Item 2 - 85 Westminster Road, Gladesville - LDA2022/0334

Proposal: Site establishment and preparation works comprising excavation (for previously approved basement levels) and construction of shoring walls.

City of Ryde Local Planning Panel Report

DA Number	LDA2022/0334
Site Address & Ward	85 Westminster Road, Gladesville NSW 2111 Lot 10 Sec 1 DP 2183 (East Ward)
Zoning	R2 Low Density Residential under RLEP 2014
Proposal (as amended)	Demolition of existing 3-storey dwelling and construction of a new 3-storey dwelling, swimming pool and carport
Property Owner	Mr Paul Miles
Applicant	Mr Jonathan Spicer
Report Author	Ben Tesoriero – Consultant Planner, CPS
Lodgement Date	25 October 2022
Notification - No. of Submissions	Yes. - 2 x submissions from first notification - 1 x submission from amended plans notification
Cost of Works	\$1,552,826.46
Reason for Referral to LPP	Contentious development – Departure from development standards. Development results in a 22.53% contravention of Clause 4.3 Height of Buildings under RLEP 2014. <i>Schedule 1, Part 2 of Local Planning Panels Direction</i>
Recommendation	Refusal
Attachments	Attachment 1 – RDCP 2014 Compliance Table Attachment 2 – Arch

Figure 12 Section B showing 9.5m height above existing ground level established by the current building on site.
Source: Applicant's architectural plans, marked up by CPS.

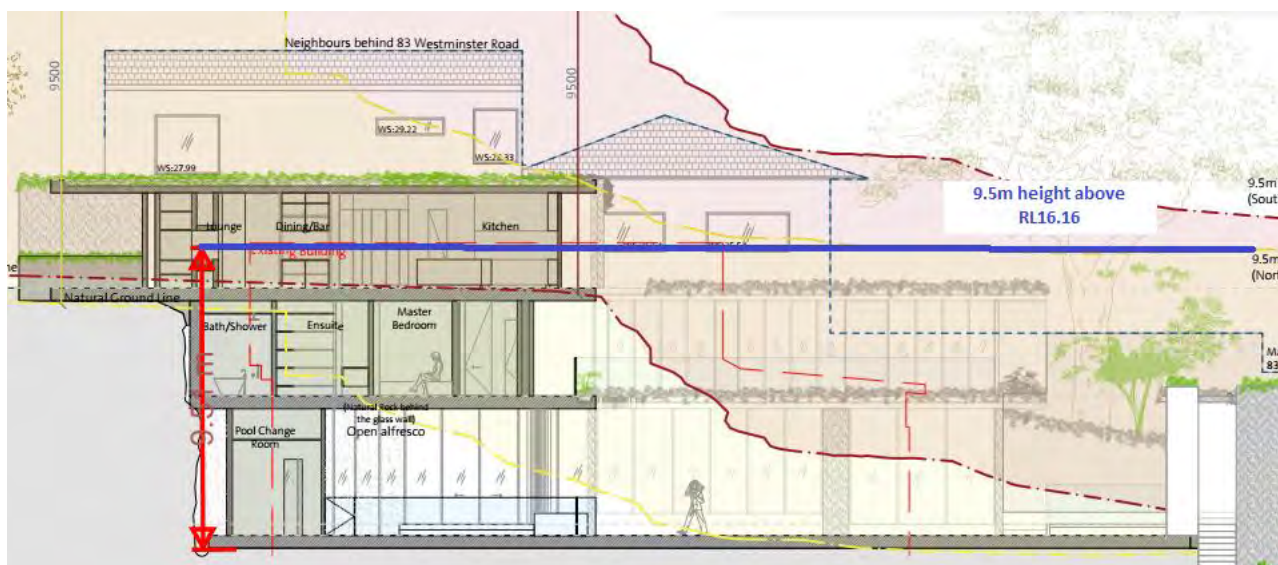
When applied to the proposed development on the subject site, the existing ground level is RL16.16, and the ridge of the third storey roof is RL27.800. This results in a vertical distance of 11.64m, therefore contravening the building height development standard by 2.14m, or 22.5%. The heights are shown in **Figures 12 and 13**.

Note: The Applicant's written request indicates the building height contravention to be 11.84m, or a 24.63% variation to the standard. However it is likely this measurement is taken from the underside of the slab level. The Council assessment is measured to the top of the existing ground level slab, hence the small difference in calculation.

Figure 20 Bush Fire Prone Land Map. Yellow identifying Vegetation Buffer.

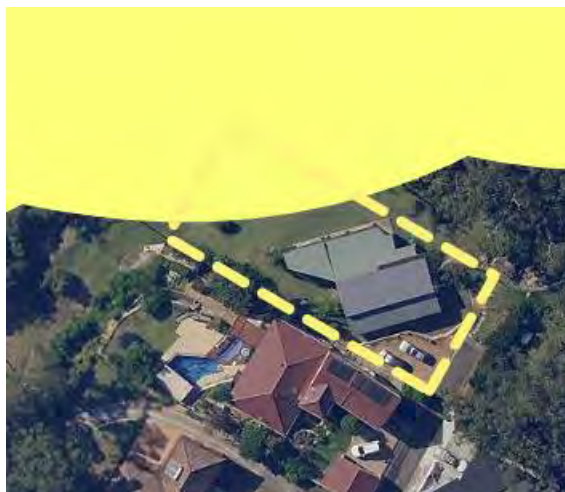
Disagreed. Only the north-western corner of the property is bush fire affected given the proximity of the Field of Mars Reserve (**Figure 20**). Despite this, the bushfire affection should have no bearing on the development's building height.

The written request draws no nexus between the necessity for the 11.64m building height as a consequence of the bush fire affection. The existing dwelling house is evidence that a three-storey dwelling can be accommodated within the 9.5m building height standard. Pursuing floor to ceiling heights of 4m at the first storey (and 3m above) is a design choice, not a necessity because of the bush fire affection.

Figure 1

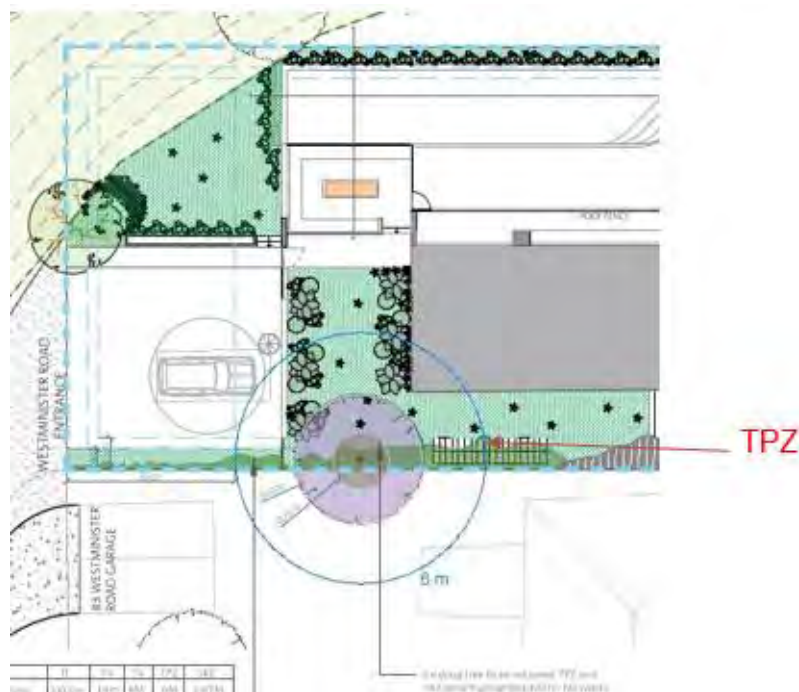
The tree on site along the western boundary will incur a major encroachment into its Tree Protection Zone (TPZ), see Figure 1

An Arboricultural Impact Assessment (AIA) is required of all trees on site, trees on adjoining sites where any part of the development will encroach into the Tree Protection Zone of those trees and any street trees. This Assessment is to be carried out as per the requirements of Australian Standard AS4970-2009 Protection of trees on development sites. In the AIA must consider the impacts of the development including:

Figure 33 Extract of Survey prepared by TECA Management Pty Ltd dated 13/09/2022.

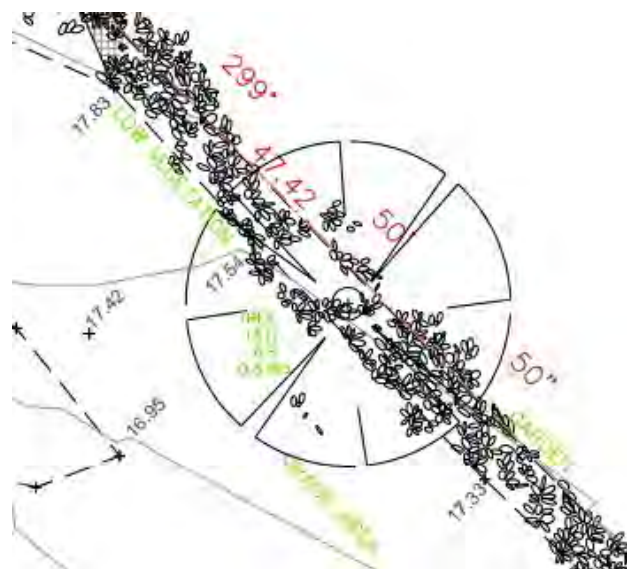
The DA was accompanied by a survey prepared by TECA Management Pty Ltd dated 13/09/2022. This survey references a tree located along the southern boundary with a 14m height, 6m spread and trunk diameter of 0.5m. (**Figure 32**). This detail was utilised to calculate the Structural Root Zone (SRZ) and Tree Protection Zone (TPZ) of the existing tree nominated as being retained.

The consultant who has been engaged to undertake an assessment of this development application (CPS), has obtained advice from CPS's internal AQF Level 5 Arborist. The advice concurs with Council's Landscape Architect referral dated 27 April 2023 that the proposed works will result in a major encroachment of the TPZ (17%).

Figure 33 shows the development includes retaining walls running along the southern side of the nominated garden sited between the garage and lower ground floor. Beneath the retaining wall is contiguous piling which could sever roots of the existing tree. The DA has not been accompanied by an Arborist Report. The extent of encroachment proposed, which is defined as 'major' in accordance with Australian Standard AS4970:2009, is unacceptable and forms part of the recommendation for refusal.
